COMMUNITY BOARD FEEDBACK PACKAGE

DINING OUT NYC

Business Name: WESTVILLE	
Cafe Address: 88 7TH AVE, NEW YOR	RK, NY, 10011
Application Number: 20240725010037	
CB Review Deadline (on date or next busing NYCDOT Internal Use Only	ness day): 01-18-2024
Sidewalk Cafe Setup Feedback:	Community Board chooses to WAIVE review
the required clear path, the applicant has ag	t and dimensions: or the required 10 foot pedestrian clear path. To provide for greed to relocate the 2 tables with 2 seats each on the acce the footprint of the cafe. The applicant has provided
Comments related to pedestrian flow (i.e., visbilit	y, safety , potential crowding):
Comments related to potential conflicts with exis	sting curb use (i.e., planters, bike racks, bus stops):
Please check one of the recommendations below, the above application:	either approval, denial, or approval with modifications relating to
Community Board recommends approval	Community Board recommends denial
Community Board recommends approval w/ r	nodifications

SECTION 1: Site Plan

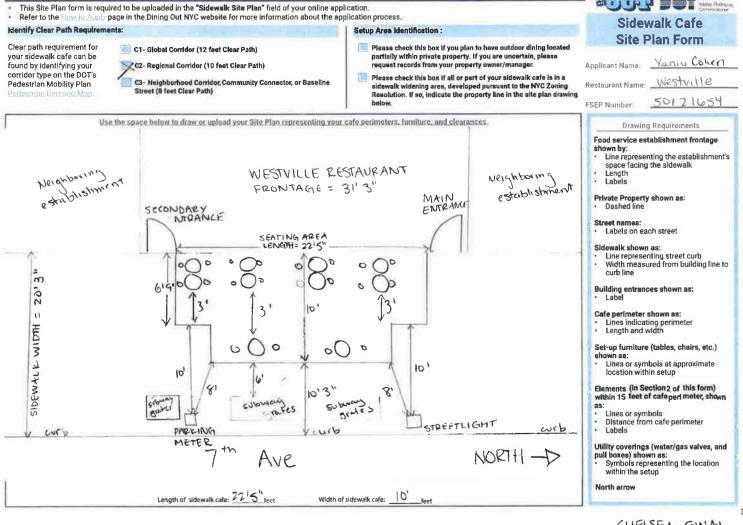
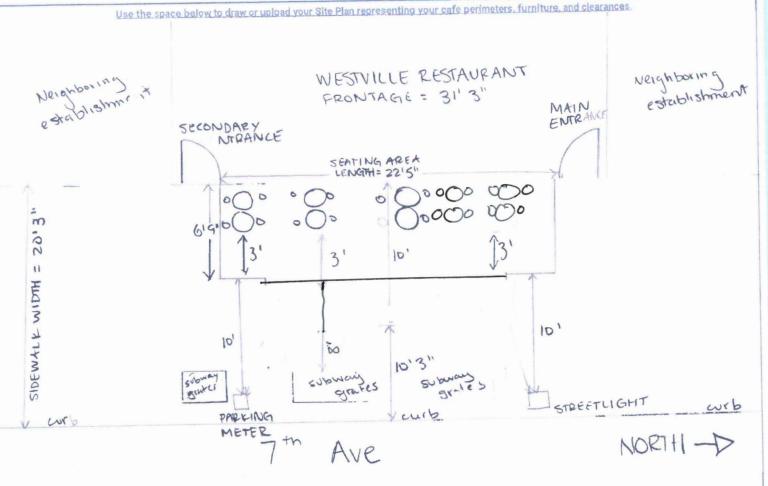
of the sidewalk cafe. Applicant has agreed	rian clear path, MCB4 requests modifications to the layout to these modifications, has relocated the 2 tables with 2 as reduced the cafe footprint, and has provided the attached
Applicant acknowledges and agrees to modif	ications relating to the above referenced application
	e with modifications relating to the above referenced application. If with documentation of such agreement for NYC DOT's consideration.
Nelly Gonzalez	Monumbe) 1/17/25

*REVISED SITE PLAN
